Cabarrus County Planning and Zoning Commission Meeting  
February 13, 2018 @ 7:00 P.M.  
Board of Commissioners Meeting Room  
Cabarrus County Governmental Center

**ARCH2018-00001** Architectural Design Review for Funeral Home - Cabarrus Memorial Gardens, 3892 NC Highway73E (PIN#5640-98-4952).

**PLANNING STAFF REPORT  
CABARRUS COUNTY PLANNING AND ZONING COMMISSION**

SHEET TITLE:  
**CONCEPTUAL SITE PLAN**

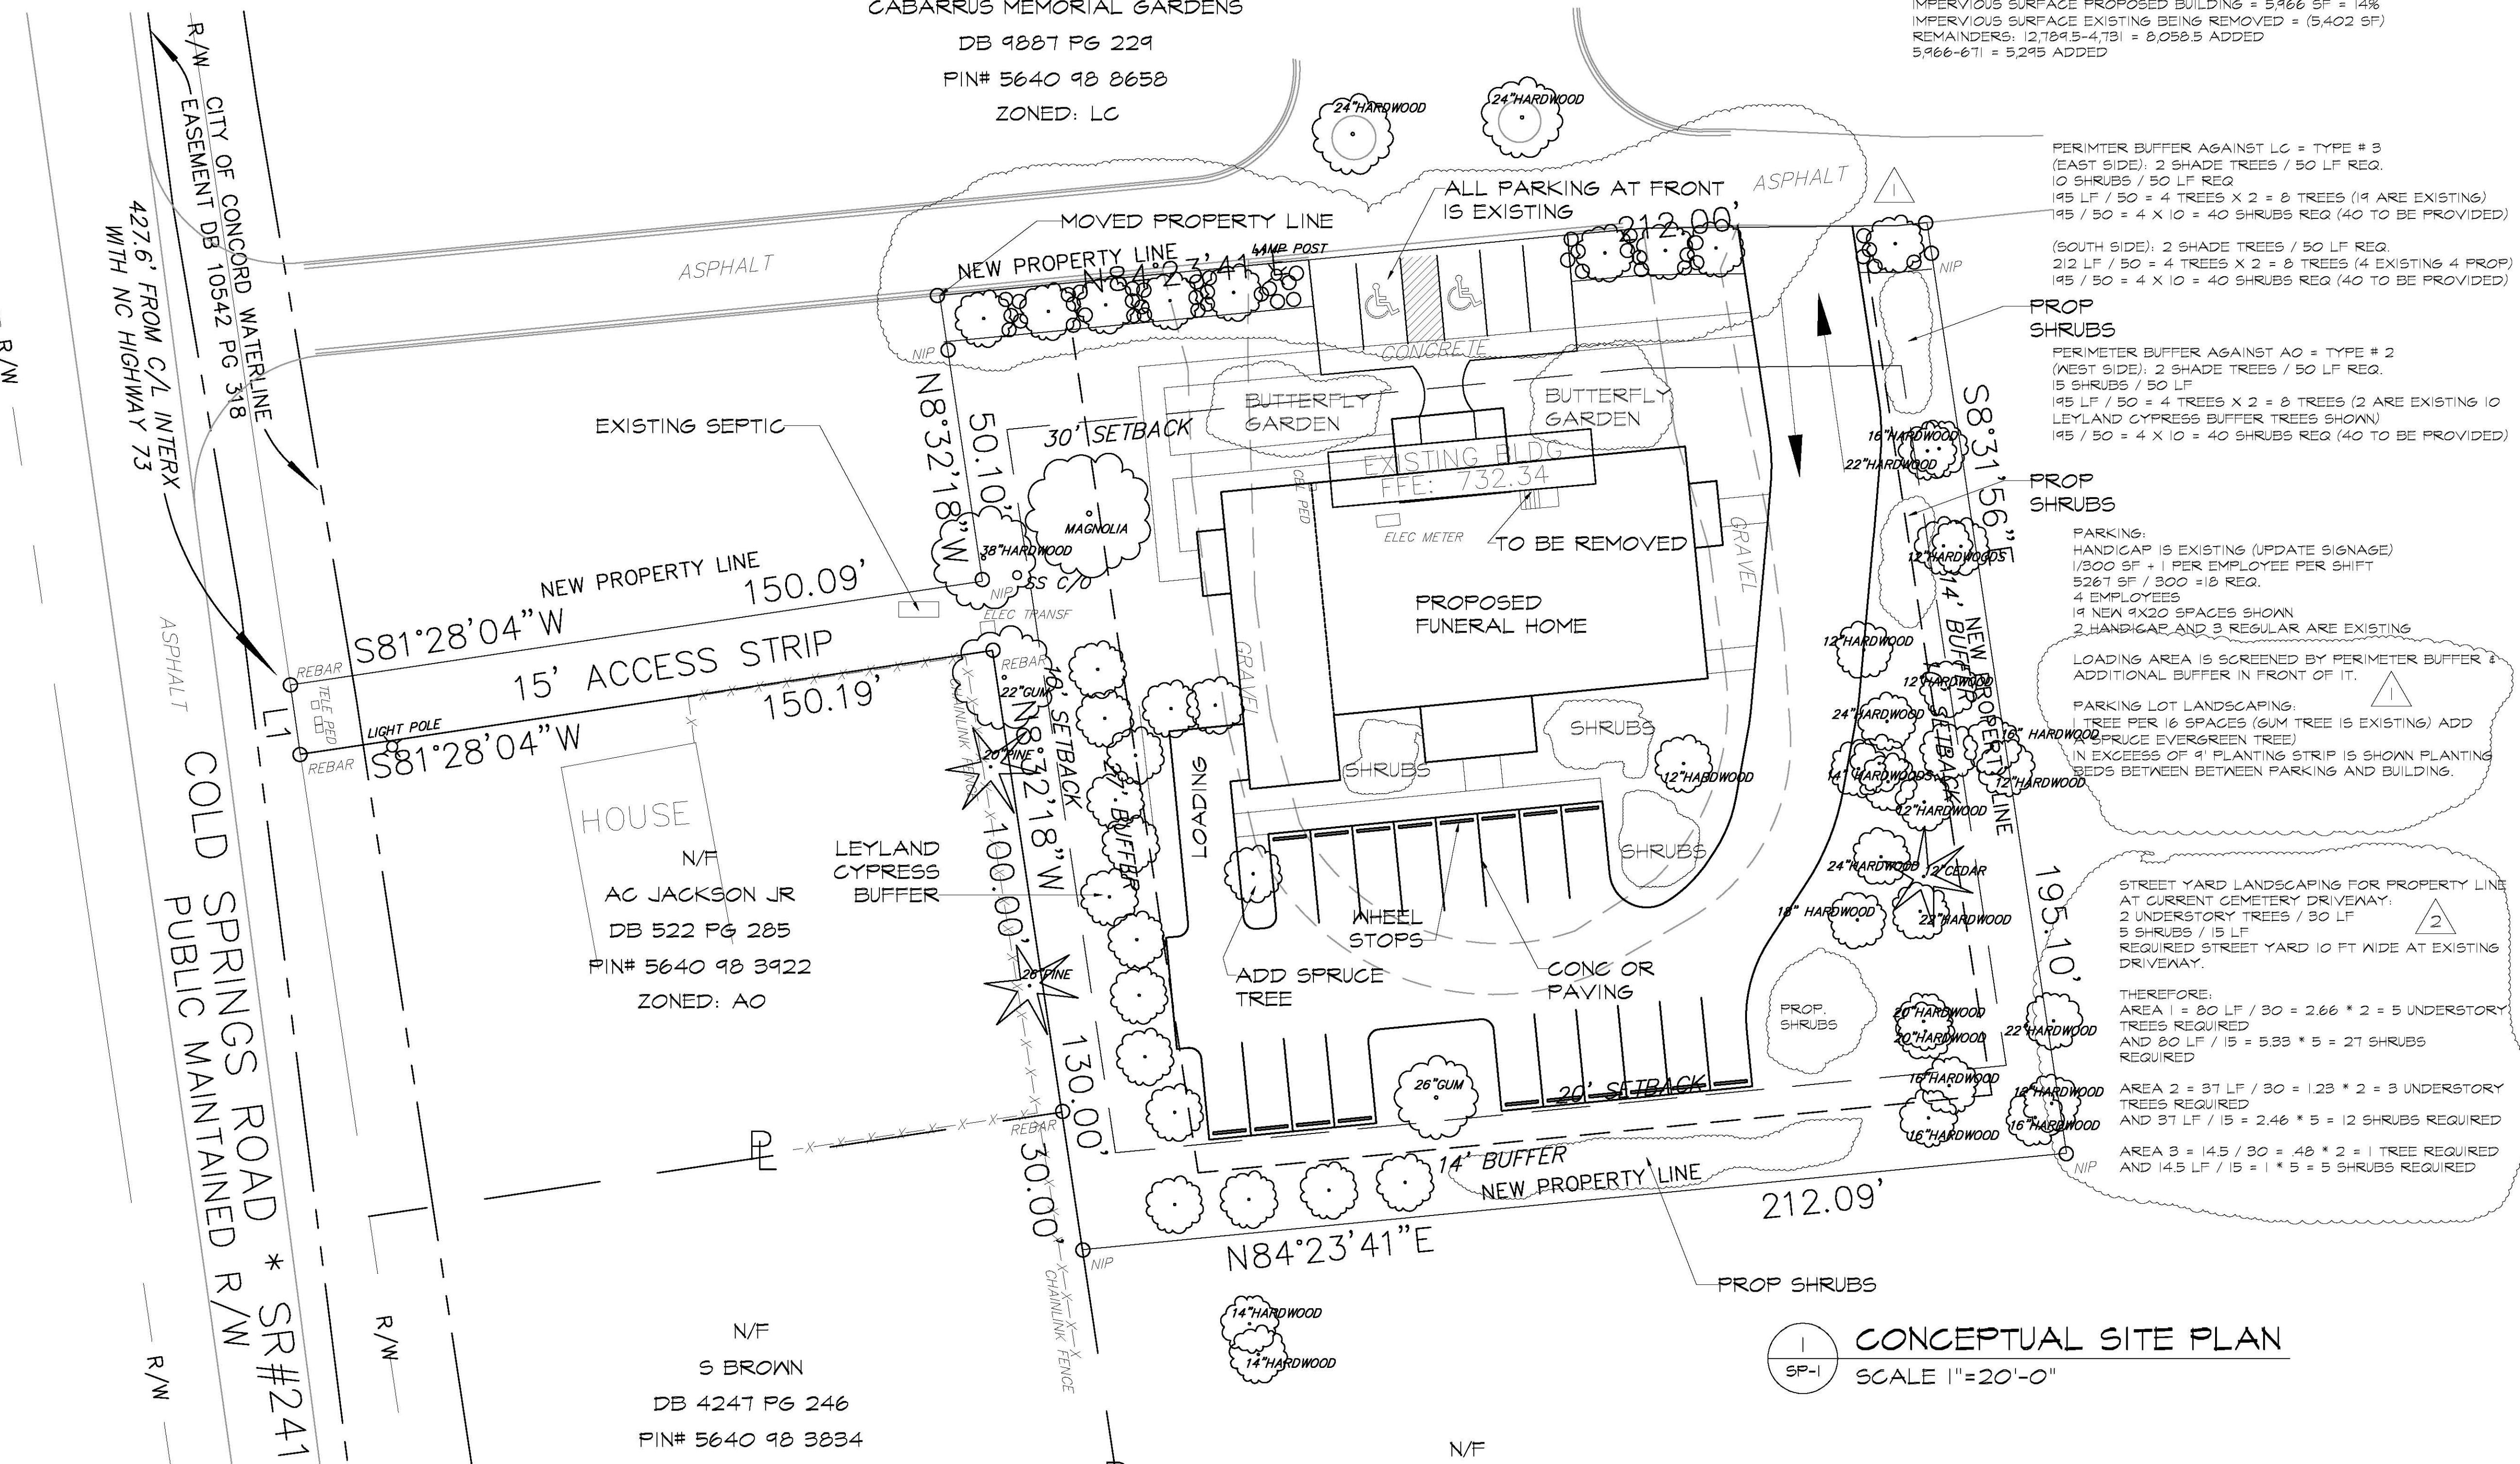
The Applicant is proposing 24 parking spaces, which includes 2 handicap spaces, which meets the parking requirements of Chapter 10 of the Cabarrus County Development Ordinance. Five of the parking spaces are existing and two of the five are the handicap spaces. The parking requirements of Appendix B encourage parking to be located to the side or the rear of the proposed structure. The majority of the proposed parking is located to the rear of the structure; however the five existing spaces will be located in front of the proposed structure. The current property line bisects the five existing spaces. The Applicant is willing to shift the property line to align with the existing driveway and this is reflected in the site plan that was submitted for review. The property line will need to be shifted for the site plan to comply with the Ordinance.

Mr. Collins said in his staff report that he mentioned that the landscaping plan that was submitted meets the requirements. But, with regard to that landscape plan, the plan does meet the requirements for the Ordinance for the most part. Due to an oversight on his part, the length of the parking spaces up front, which are about 54 feet, was omitted in the street yard planning requirements. This will equate to two additional shade trees or four additional under story trees and 18 additional shrubs.

1. Site plan review and approval is required subsequent to Board of Adjustment approval in order to ensure compliance with all applicable development requirements and conditions.
2. The front property line shall be shifted to align with the southern side of the existing driveway.

3. The Applicant shall procure any and all applicable federal, state, and local permits prior to commencement of the project.
4. The Applicant will compensate for 54 additional feet in landscaping calculations for the street yard.

1. Site plan review and approval is required subsequent to Committee approval in order to ensure compliance with all applicable development requirements and conditions.
2. The front property line shall be shifted to align with the southern side of the existing building.
3. The applicant shall procure any and all applicable federal, state and local permits prior to commencement of the project.
4. The applicant will add 54 feet of landscaping in the street yard.

REVISIONS:  
 1. 02.01.2018  
 1. MOVED PROPERTY LINE PER COUNTY REG.  
 2. 02.05.2018  
 1. ADDED ST. YARD LANDSCAPING

SHEET  
**A-4**  
 TOTAL # OF SHEETS: .

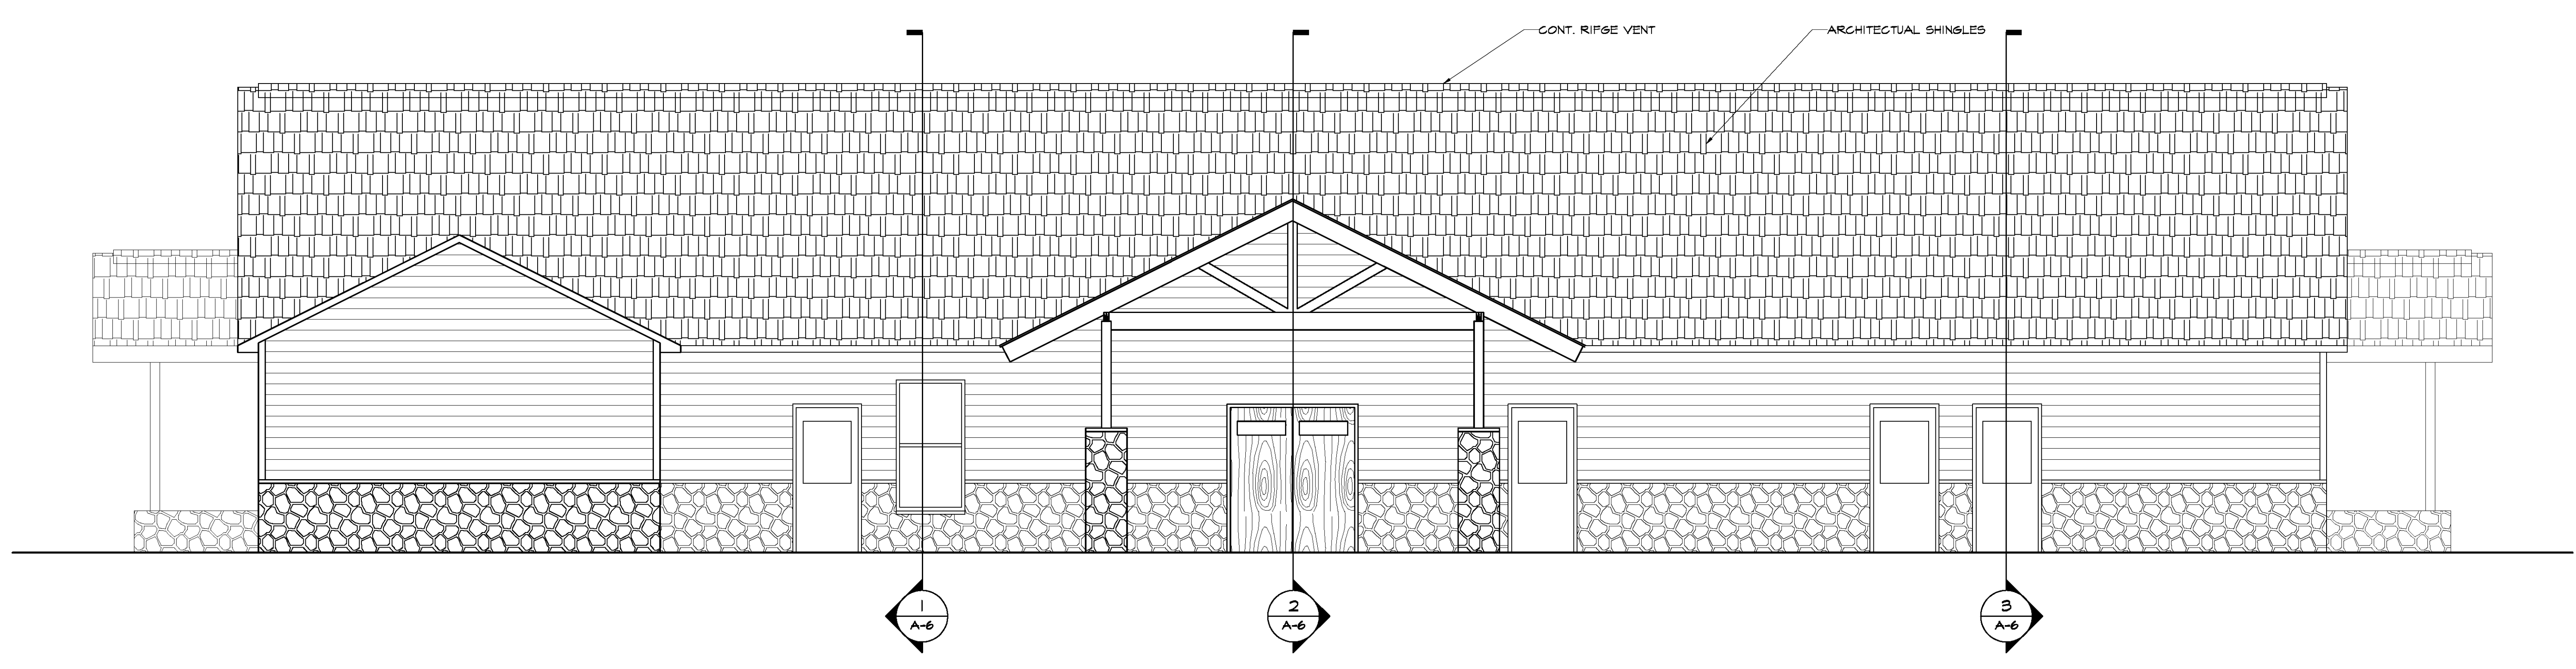
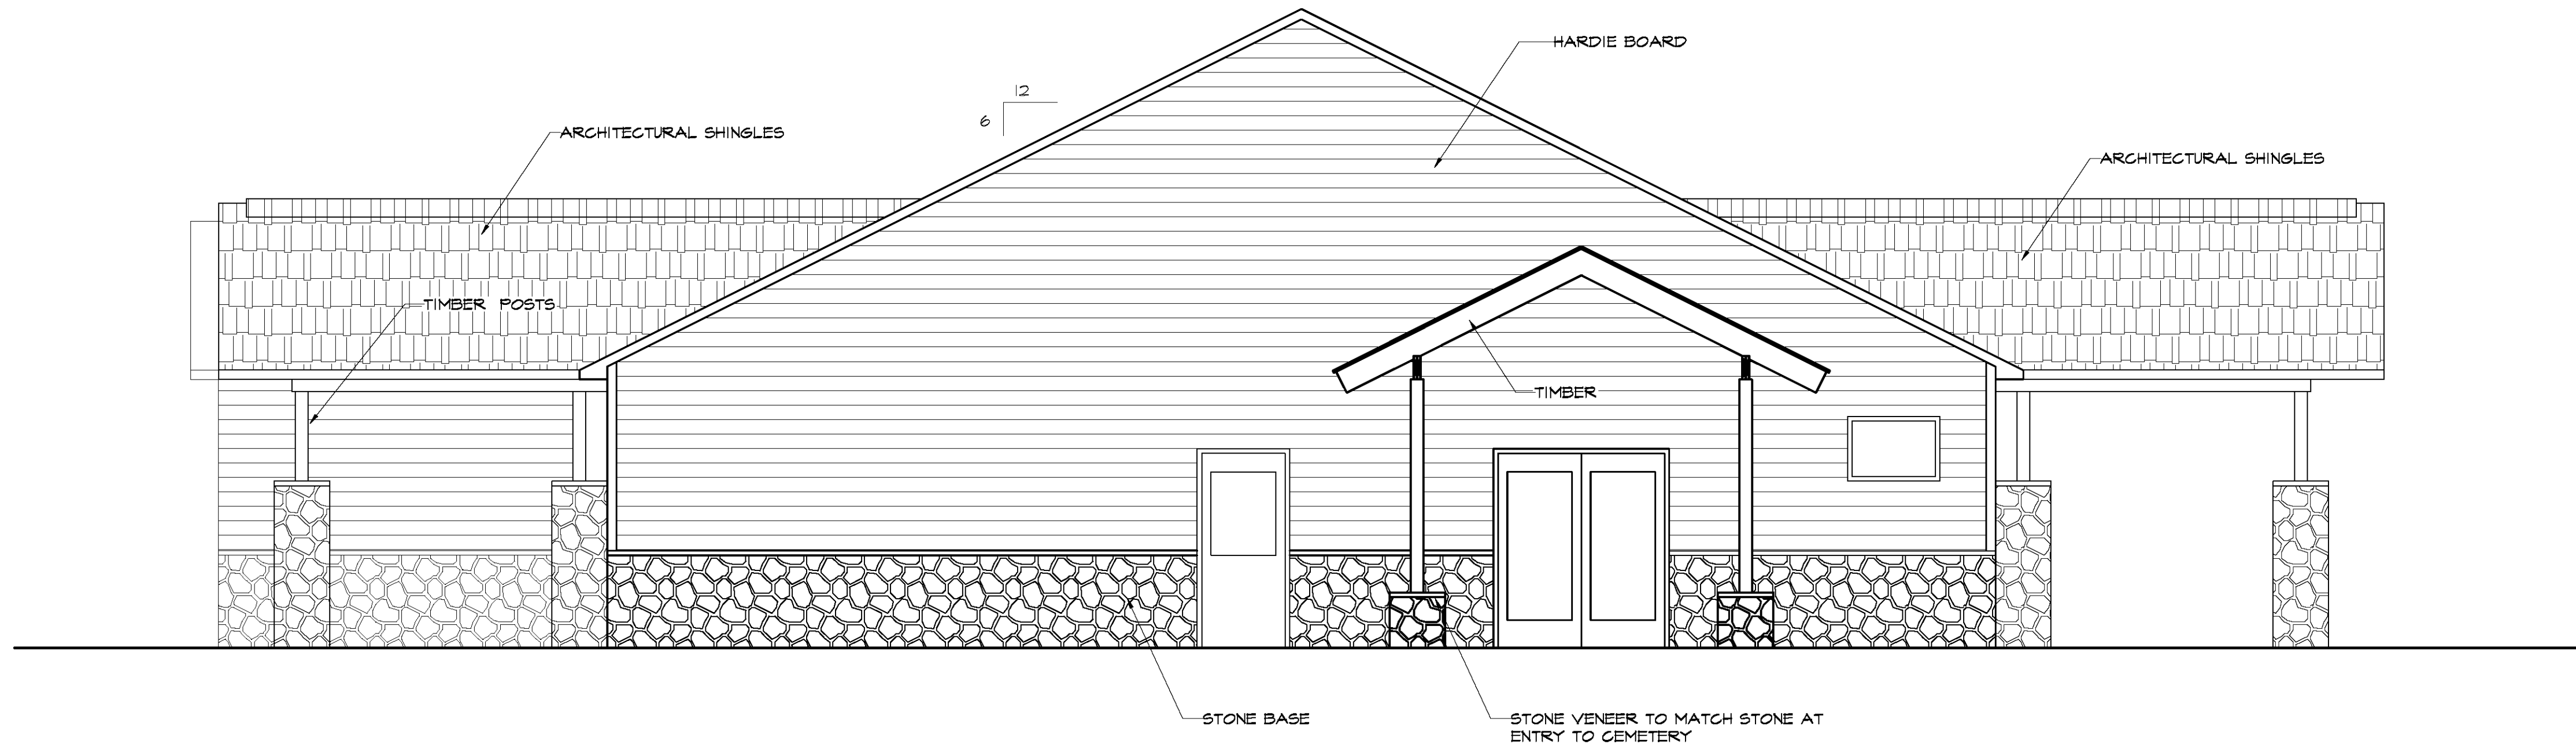
With respect to the articulation of the proposed structures, the Applicant states that the proposed exterior façade of the building consists of two materials, a stone base and hardie board siding, windows along the front façade and canopies on all four sides of the structure which would meet the requirements of Appendix B of the Ordinance.

The Ordinance requires that canopies be constructed of material designed to complement the streetscape and have a minimum overhead clearance of eight feet. The Applicant is proposing that the canopies be constructed of exposed wooden trusses, with wooden decking attached atop with the rest of the roofing membrane. The lowest clearance of the proposed canopies is 8.5 feet.

The Ordinance states that forms and finish of materials for buildings shall be compatible with the architectural character of the adjacent area. The Applicant states that canopies will be constructed of wooden trusses to adopt styles from western NC architecture and asphalt shingles will be used for the roofing membrane.
